CMG ENVIRONMENTAL, INC.

March 16, 2004

**Re: Public Commentary on March 3, 2004 Draft
Phase IV Remedy Implementation Plan (RIP) Addendum
Former Raytheon Facility, 430 Boston Post Road, Wayland MA
DEP RTN 3-13574; Tier IB Permit No. 133939
CMG ID 2002-003**

Monitoring Well MW-43S

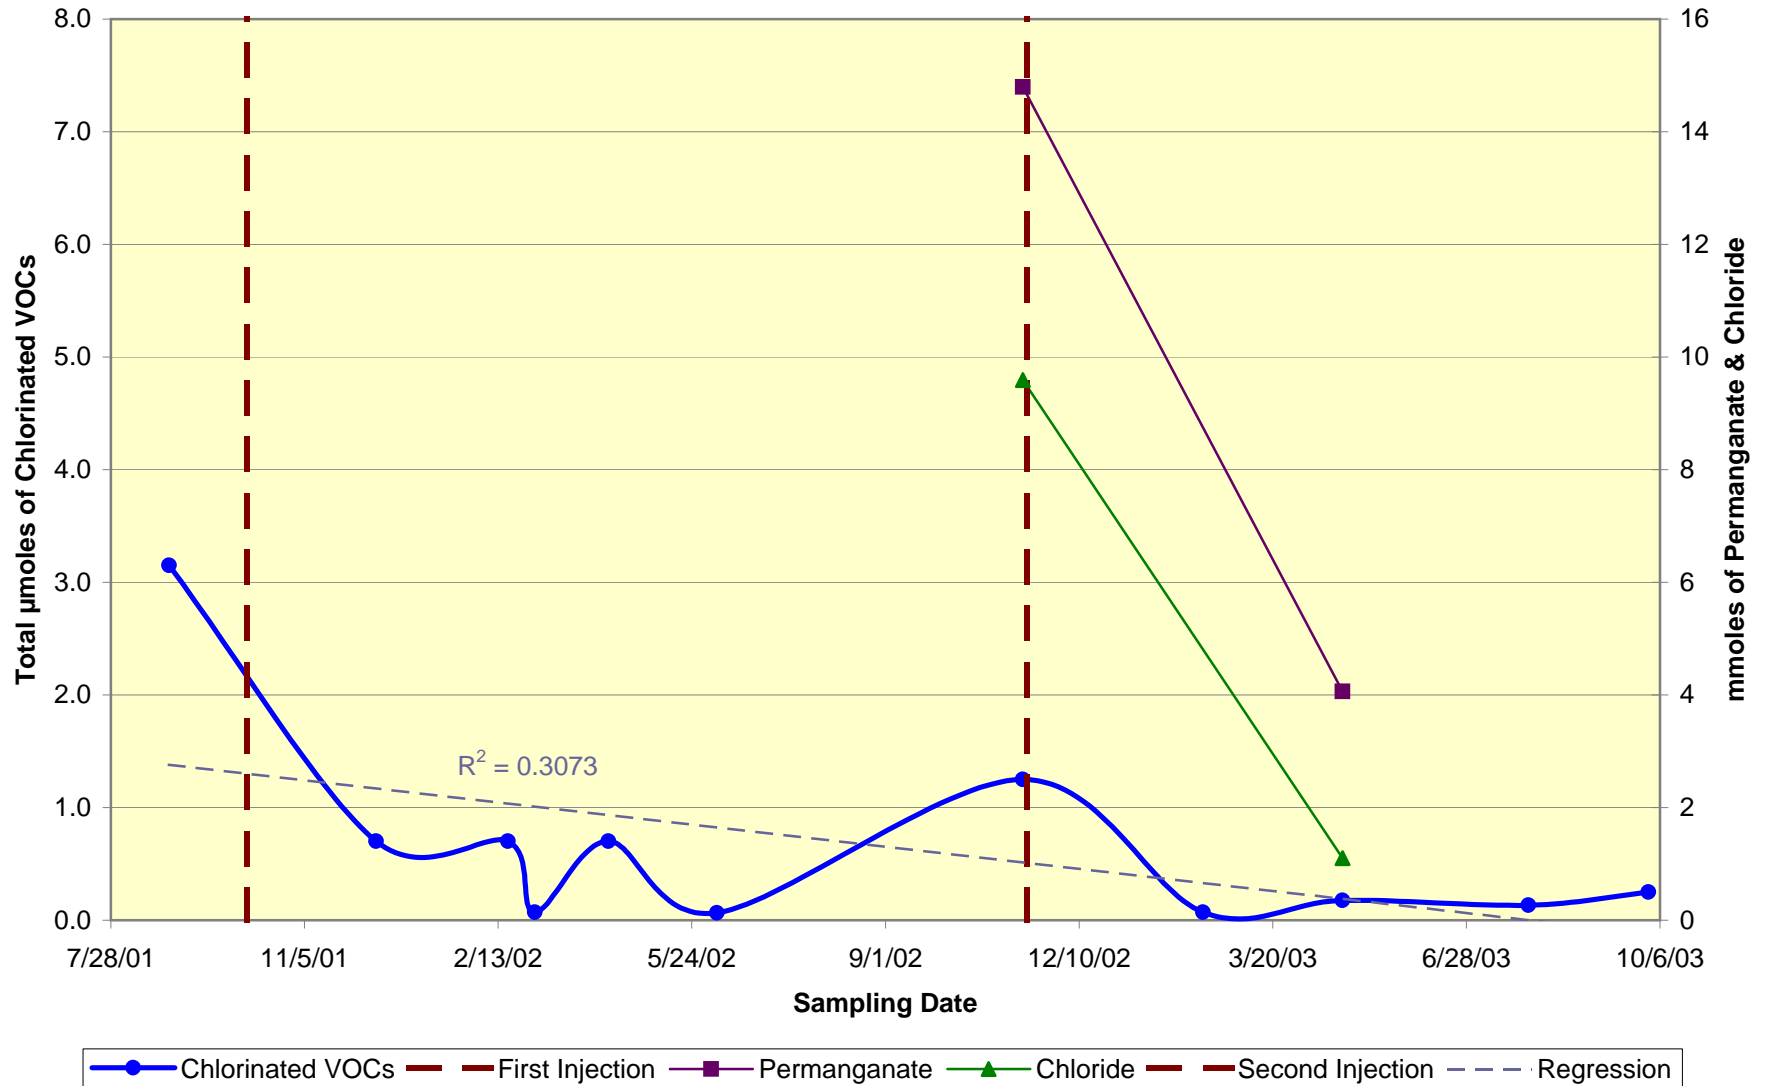
CMG took an even more detailed look at four of the monitoring wells (MW-43S, MW-102, MW-105, and MW-107). We wanted to quantify how effective the RAM pilot study was, so we totaled all chlorinated ethenes and ethanes in each analysis. For accuracy, we first converted the reported concentration values into μ moles, since these chlorinated VOCs have substantially different molecular weights. CMG then plotted the total chlorinated VOC values versus time (see attached Charts 1A through 1D). These charts also depict millimoles of total sodium permanganate residual (the sum of sodium permanganate, sodium, and manganese analyses) and chloride (which represent the residual concentrations of applied oxidant and dechlorination byproducts, respectively).

By plotting a regression line through each set of total chlorinated VOC data, CMG concludes a measurable decrease in chlorinated VOCs occurred at wells MW-43S, MW-102, and MW-105 during the RAM pilot study. Regression analysis for well MW-107 shows a slight increase over time. However, the correlation coefficients (r^2 values) show poor to very poor correlations in these four wells. This is also evident from the substantial oscillations in total chlorinated VOC

Wayland requests that Raytheon present a detailed and quantifiable assessment of the efficacy of sodium permanganate ISCO before proposing to substantially increase the scale of oxidant injections into the Town's drinking water aquifer.
